RE: The Connecticut Light and Power Company's Notice of Exempt Modification Pursuant to RCSA § 16-50j-57(a) to Existing Energy Facility Site at 272 East Main Street, Branford, Connecticut 06405 ("Notice of Exempt Modification")

BRANFORD SUBSTATION
GENERAL ARRANGEMENT - PLAN & SECTIONS - CSC

11401-92001

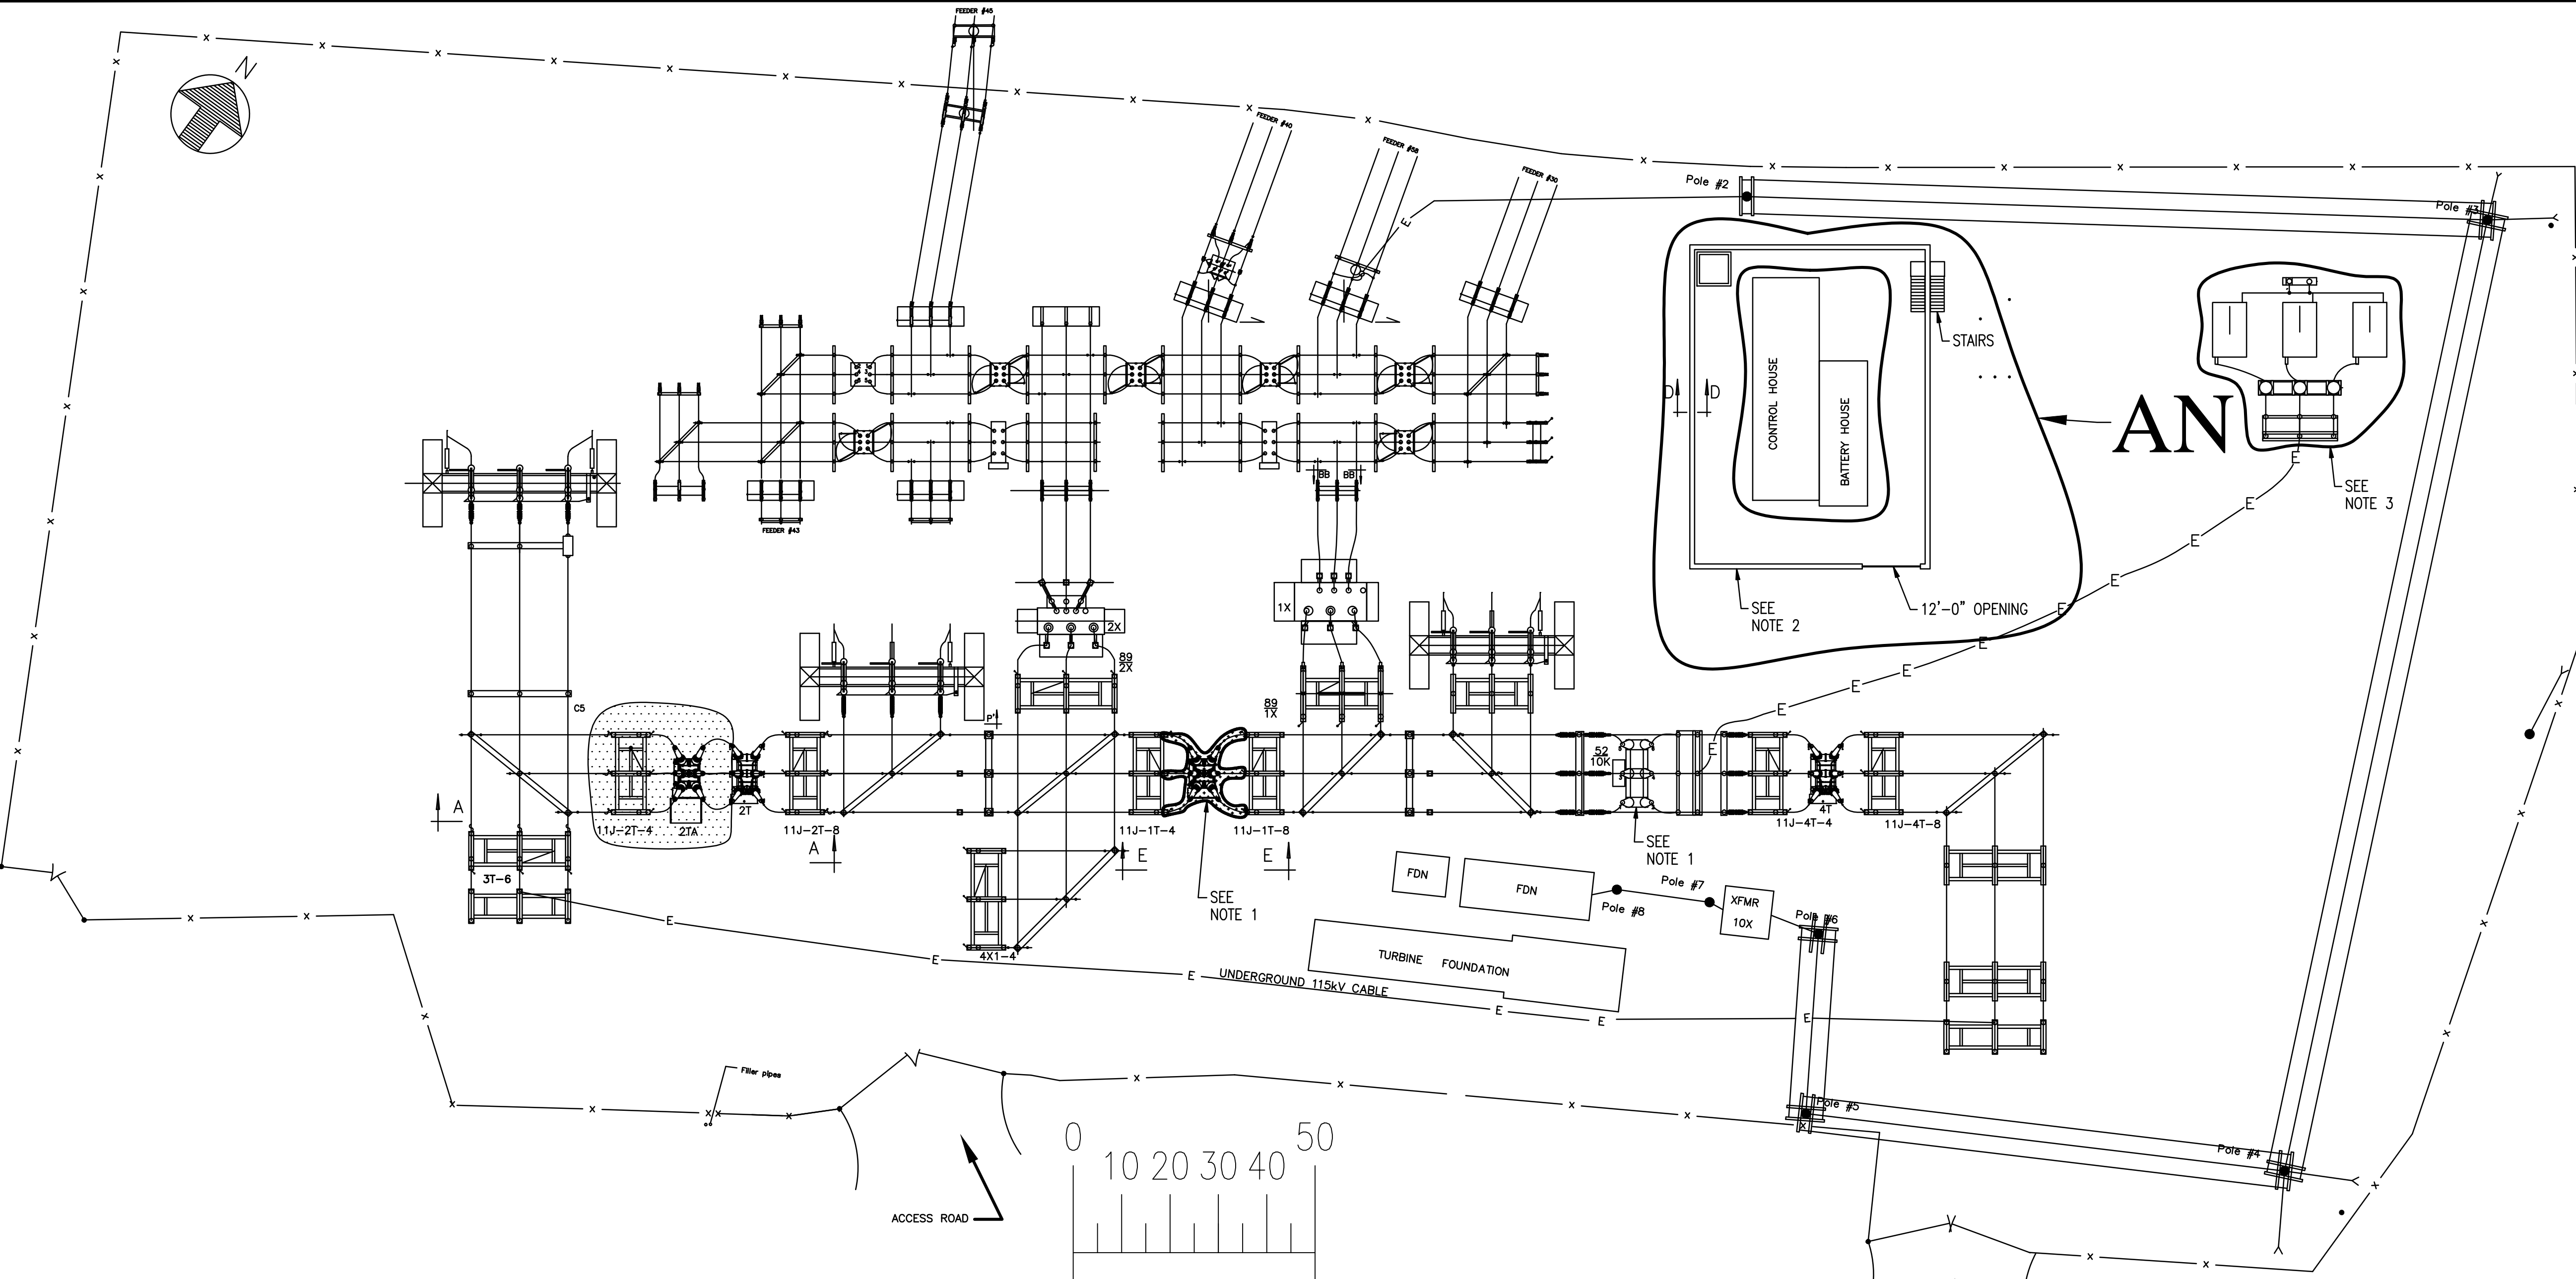
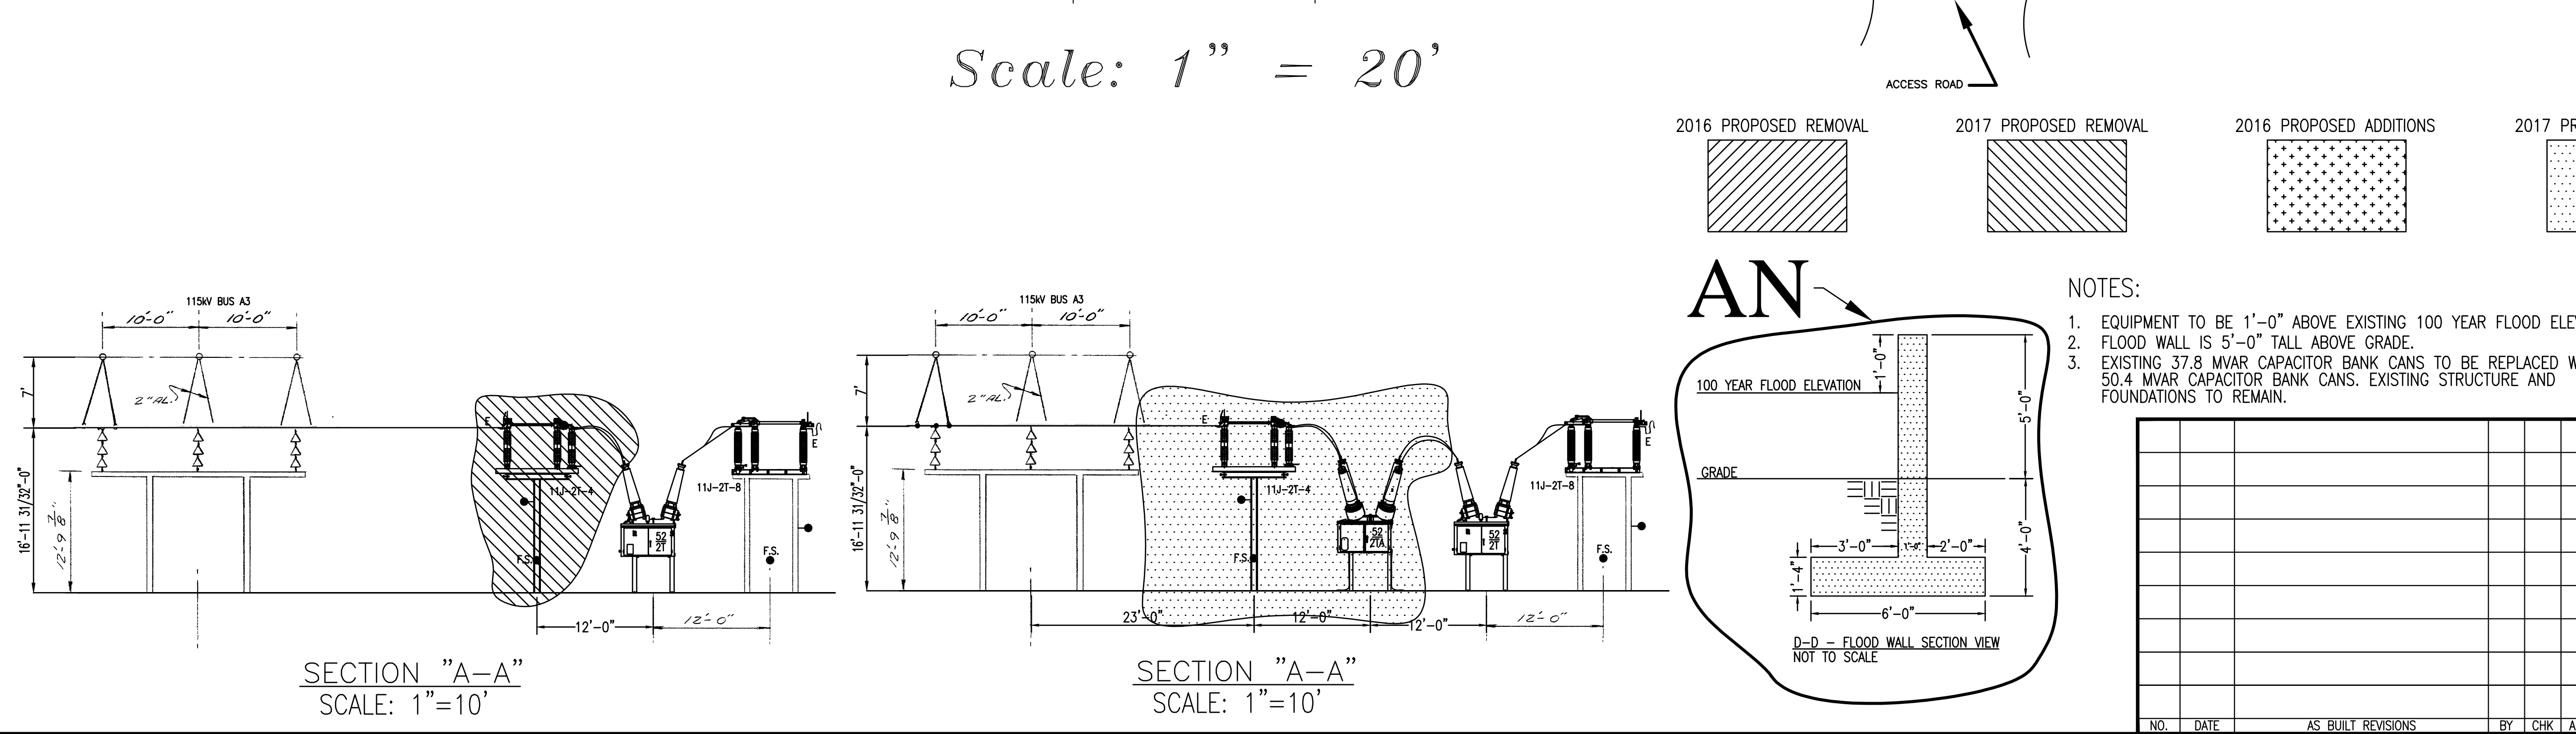
- a) Replacement of an existing 115-kV oil circuit breaker with a new 115-kV Sulfur hexafluoride (SF₆) circuit breaker on the existing foundation.

- c) Installation of a flood wall around the control enclosure to provide adequate protection against a flood event. The proposed flood wall would form a rectangle that would be approximately 66 feet long and 48 feet wide. The wall would have an above-grade height of 5 feet and it would be 12 inches thick (Section AN).

- d) Installation of a new 115-kV series circuit breaker on new foundation (Section A-A). Installation of a steel structure to accommodate the installation of the new 115-kV series circuit breaker.

- e) Relocation of an existing 115-kV manually-operated disconnect switch on new foundation to accommodate the new 115-kV series circuit breaker (Section A-A).

- f) Raising an existing 115-kV circuit breaker, control boxes and junction boxes to a height that is one foot above the 100-year flood level.

SECTION "E-E" (115kV)
SCALE: 1"=10'

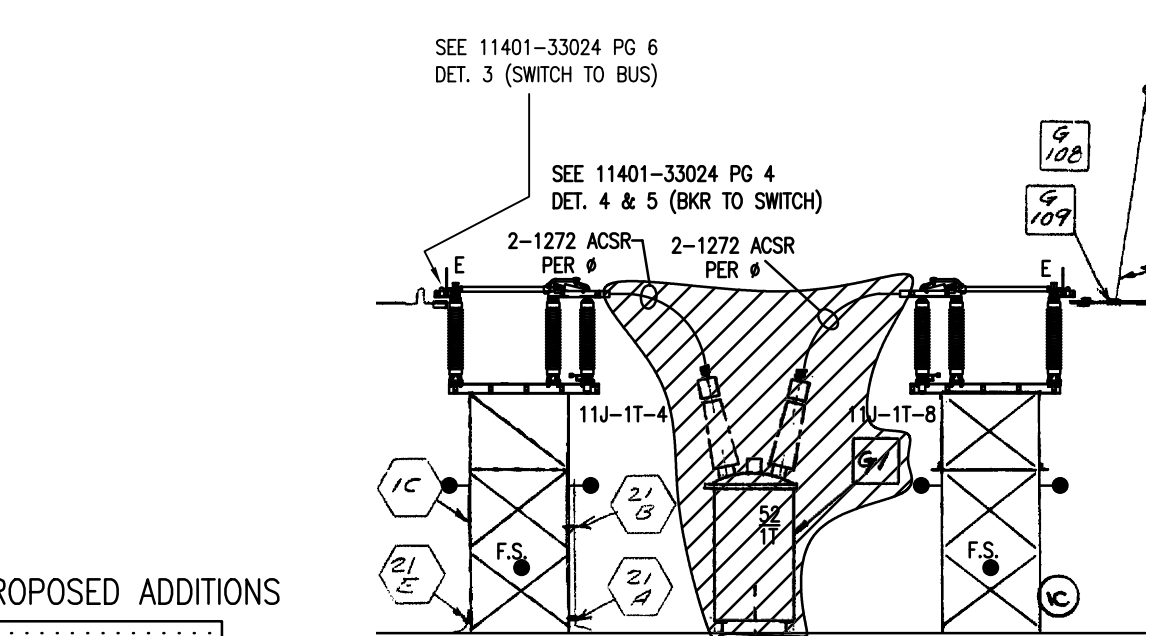
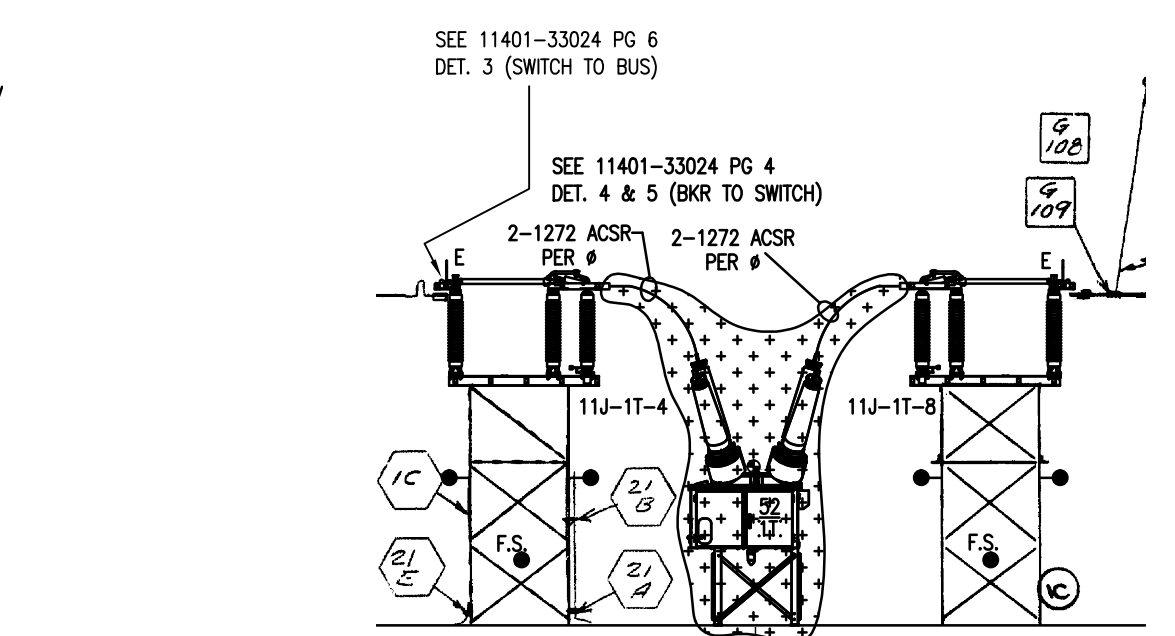
- b) Replacement of the existing 37.8-Mvar capacitor bank cans with new 50.4-Mvar capacitor bank cans. The existing capacitor bank structure, foundations, and rack will remain (Section E).
